Arlington Conservation Commission

Date: Thursday, February 6, 2025

DEP #091-0356: Notice of Intent: Thorndike Place (Continued from 01/16/2025).

The Conservation Commission will hold a public hearing under the Wetlands Protection Act to consider a Notice of Intent for the construction of Thorndike Place, a multifamily development on Dorothy Road in Arlington. Areas proposed to be altered include Buffer Zone to Bordering Vegetated Wetland and Bordering Land Subject to Flooding associated with Alewife Brook.

ESHGW=4.0
Bot System=7.0
Separation=3.0
Mound=0.756 < 3.0

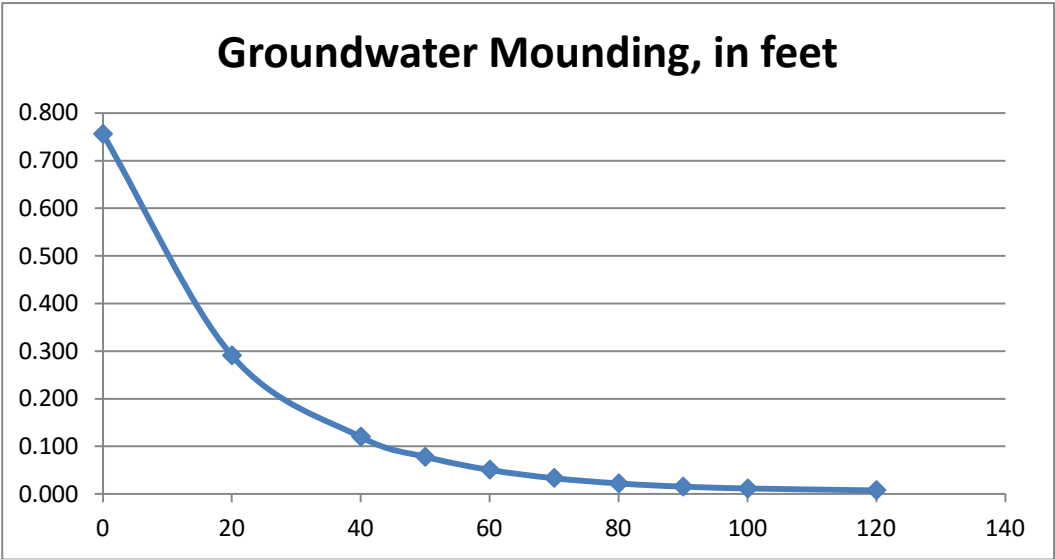
The applicant is now using this suggested value of 4.0 feet to avoid providing a groundwater mounding analysis of the stormwater infiltration system. They have adjusted the bottom of the infiltration system to elevation 8.0 and are claiming because they have 4-feet vertical separation that they are no longer obligated to provide a groundwater mounding analysis of that system.

ESHGW=4.0
Bottom System=7.15
Separation=3.15
Mound=2.946 < 3.15

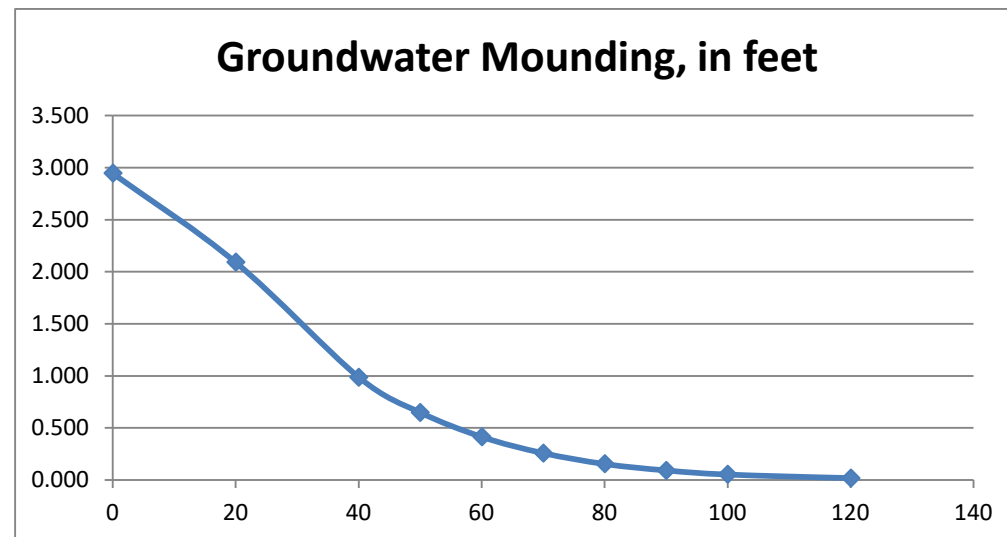
- Consistent with MMA's January 15, 2025 letter, GZA acknowledges that simultaneous infiltration from other nearby systems (e.g., System 1) would result in groundwater mounding that could interfere—and be additive on top of—mounding generated by System 7. After correcting erroneous inputs used by BSC, GZA performs their own mounding calculation for System 7 using the Hantush analytical model (i.e., BSC's selected mounding analysis method). GZA's results show a groundwater mound rising to within approximately 0.5 feet of the bottom of System 7, but this result ignores the additive influence of System 1. As demonstrated in MMA's January 15, 2025 letter, if the additive System 1 influence is considered using a comparable modeling method to BSC's, there is clear evidence of groundwater mounding rising well above the bottom of System 7. Thus, at a minimum, additional analysis is necessary to support GZA's claim that groundwater mounding will not adversely impact the drainage time of System 7, nor the rate control capability of the overall stormwater system, to the point of violating MSH requirements.
